1999-0008

Portland Commons Shopping Ctr.

Waterford Group

PB MTG 4/13

PRESENTED BY: Post-Development Watershed Map

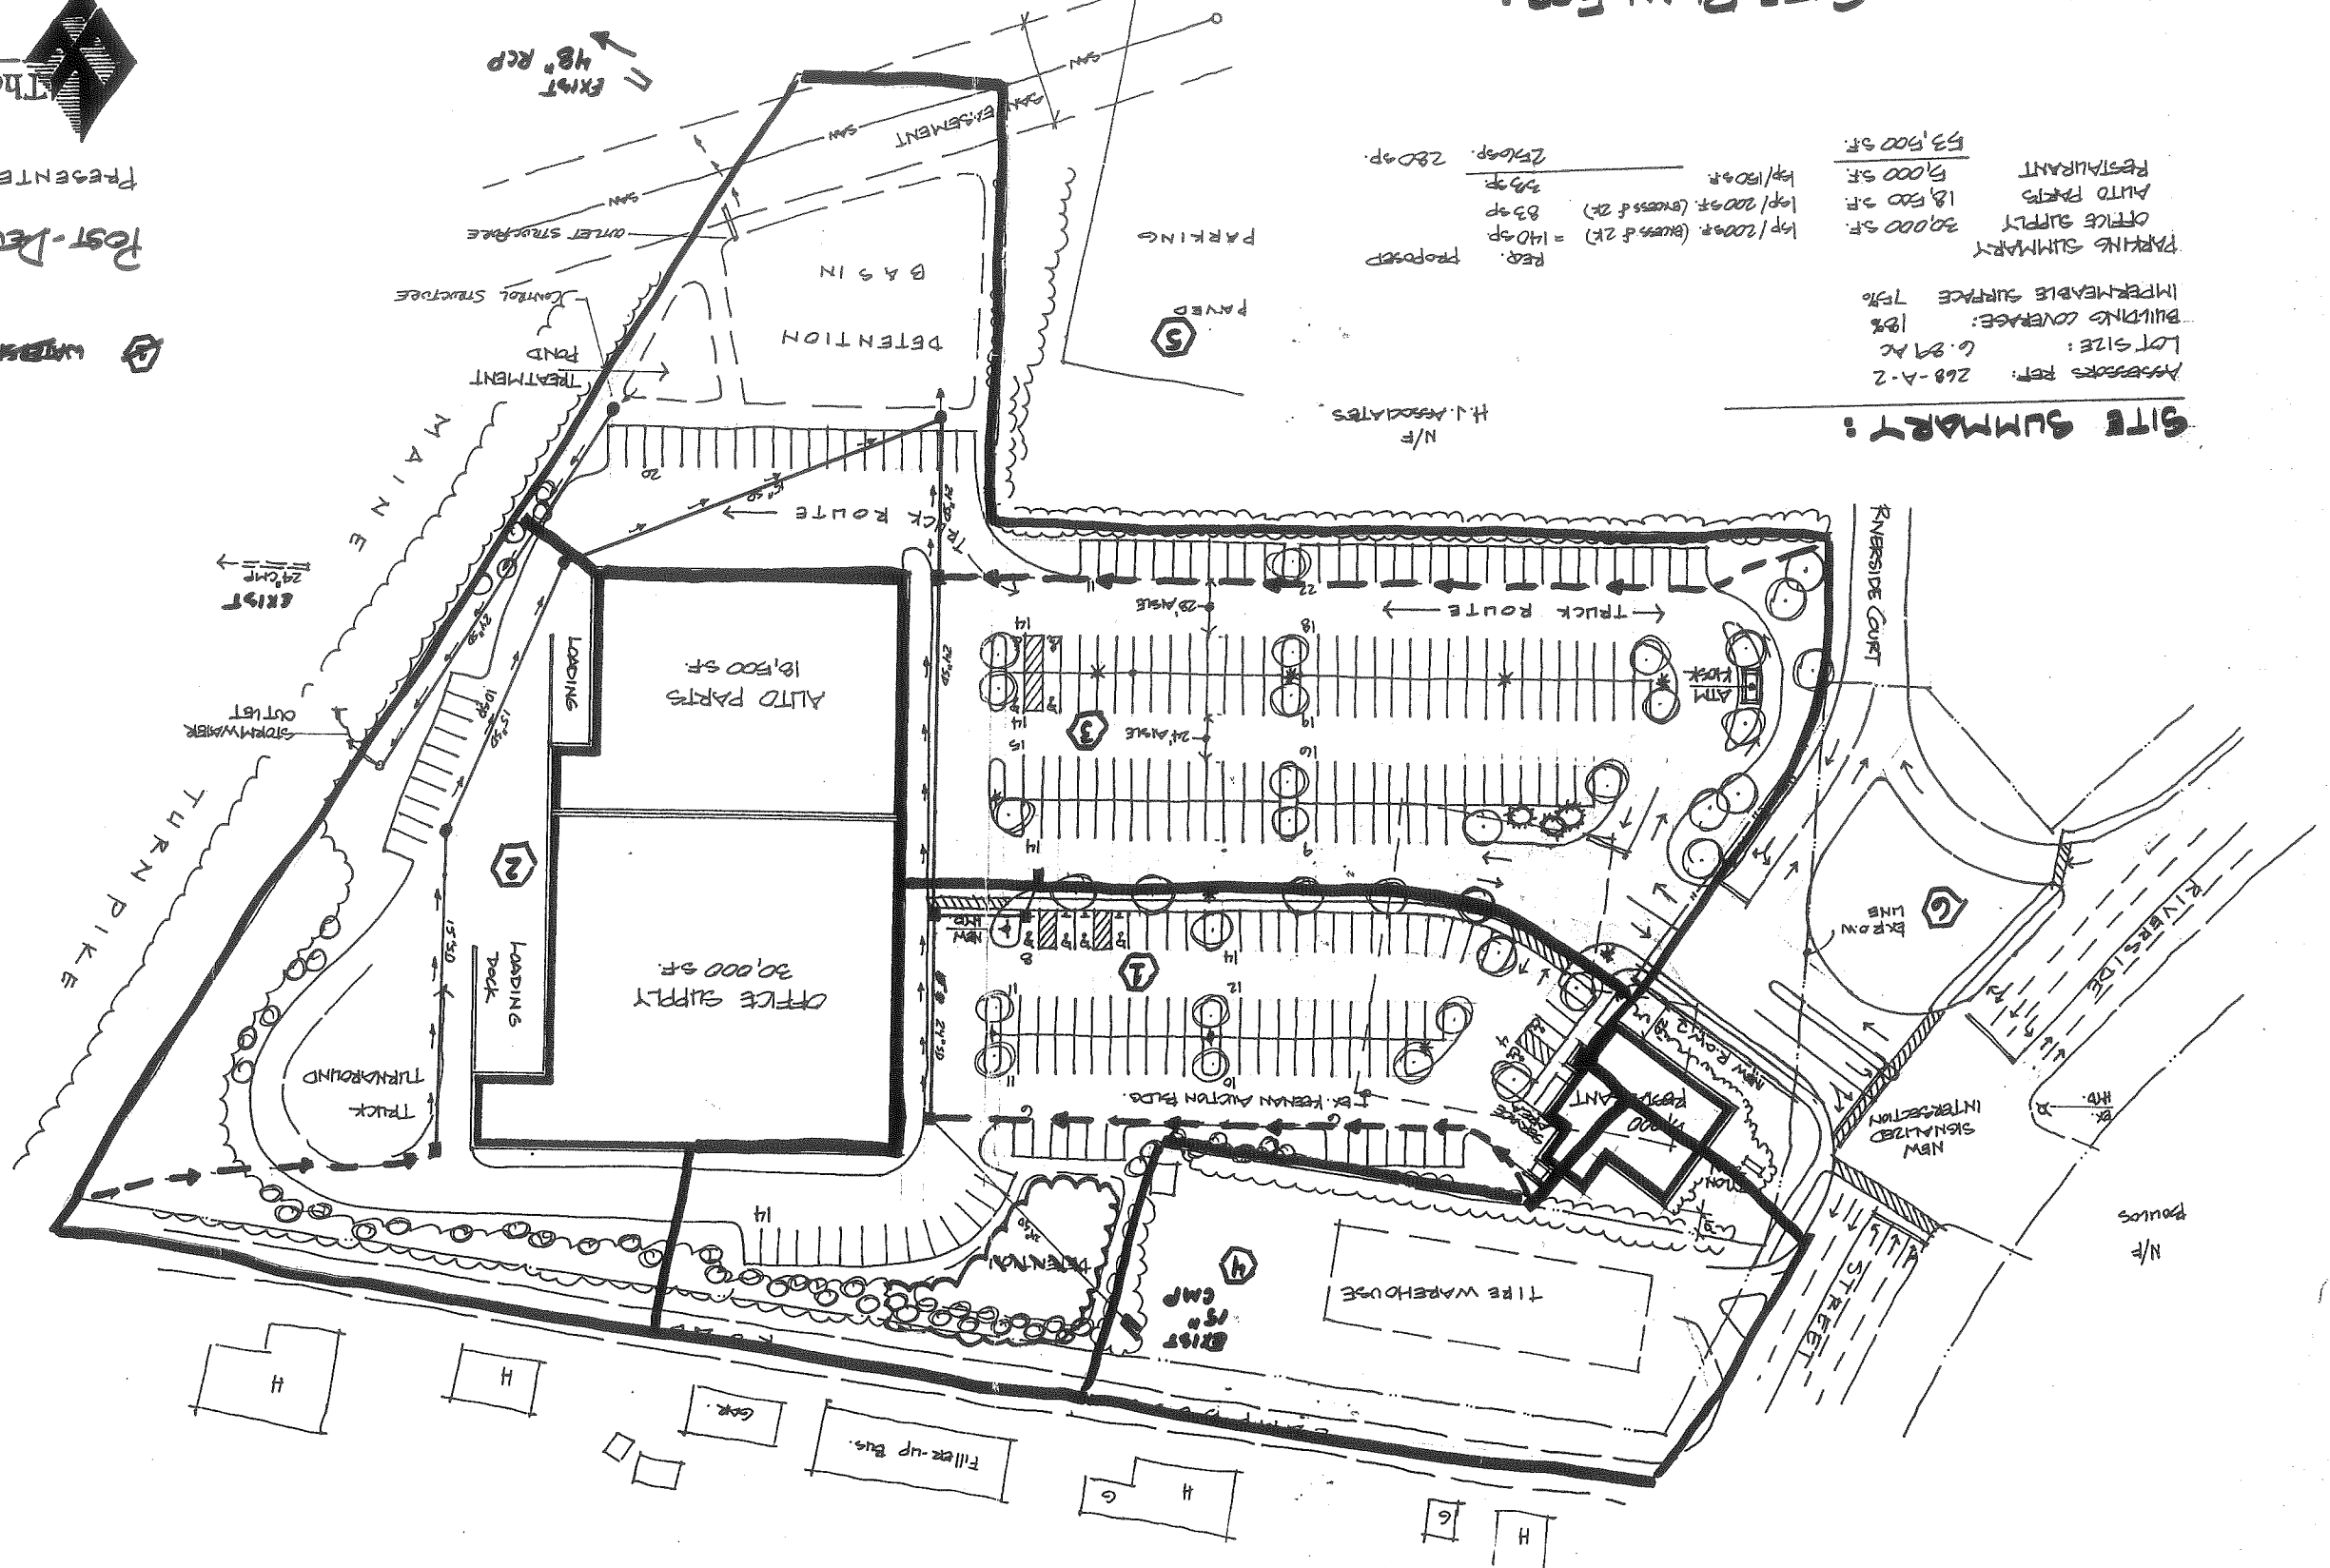
If you would refer to Watershed Map D-3, you will note that no basement drains are shown other than the one at the end of Campbell St. The property at 4 Campbell Rd and 11 Campbell Rd. Have basement drains that drain into this drainage ditch. At the time Mr. Keenan bought and extended the back of the property, the drain at 4 Campbell Rd. was crushed and blocked and nothing was done to correct this situation. On plan "B" the developer is showing a detention pond directly on top of the outlet of the basement drain to the property of 11 Campbell Rd. The drainage ditch also takes care of the storm water from Riverside St down Campbell Rd. to a detention basin at the back of Keenan property. This drainage ditch and basement drains are grandfather under drainage rights. Please refer to General Notes #19C and #20B. on site plan D3, which describe these rights as deeded by the original owner Charles Grant. A copy of this plan is enclosed with highlighted notes. I find it amusing to note that "the existing pond treats the storm water before it leaves the site and enters the CMP turnpike culvert." This detention pond will be only about 30 feet from my driveway. This will be breeding grounds for mosquitoes and other health hazards. Any kind of a detention pond in this corner cannot be allowed. I cannot imagine the DEP would allow such a catch basin so close to a residential area.

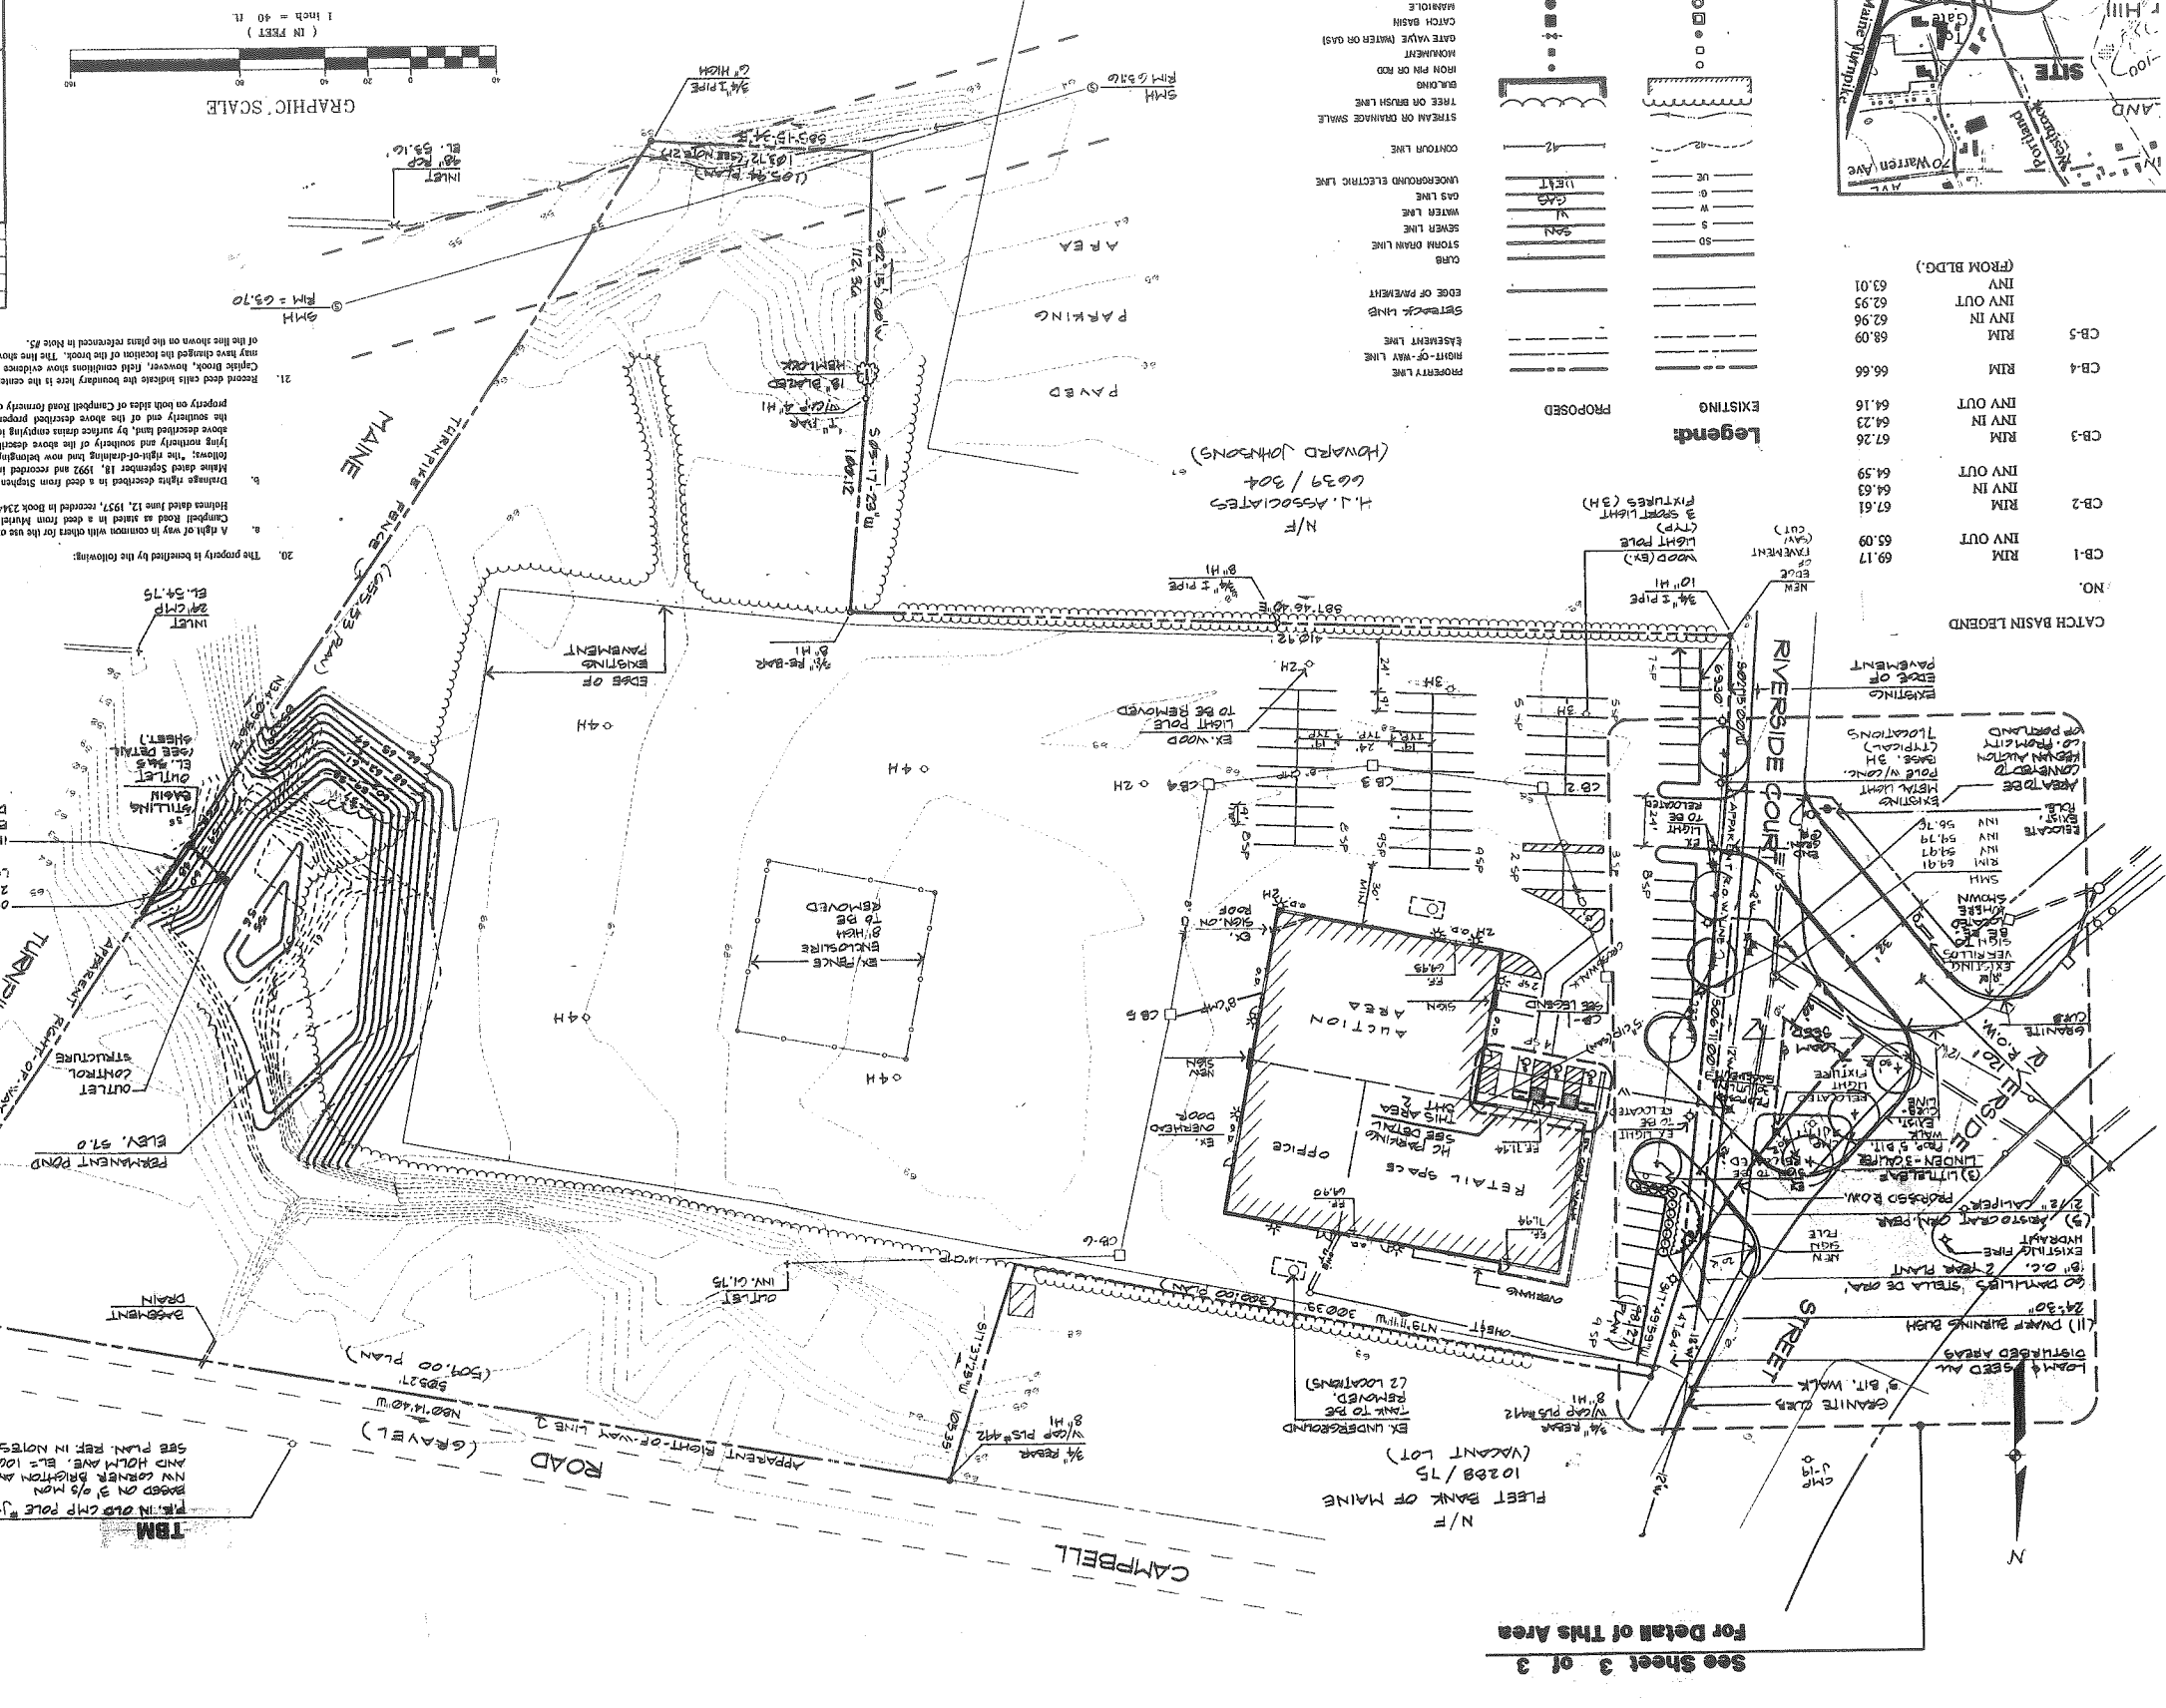
On Sheet S1, under General Notes, the Deed Book and Page has been omitted.

On Sheet S1, the plan references an "Offsite Improvement Plan" for Riverside Street. This plan was not included as part the plan and application submittal.
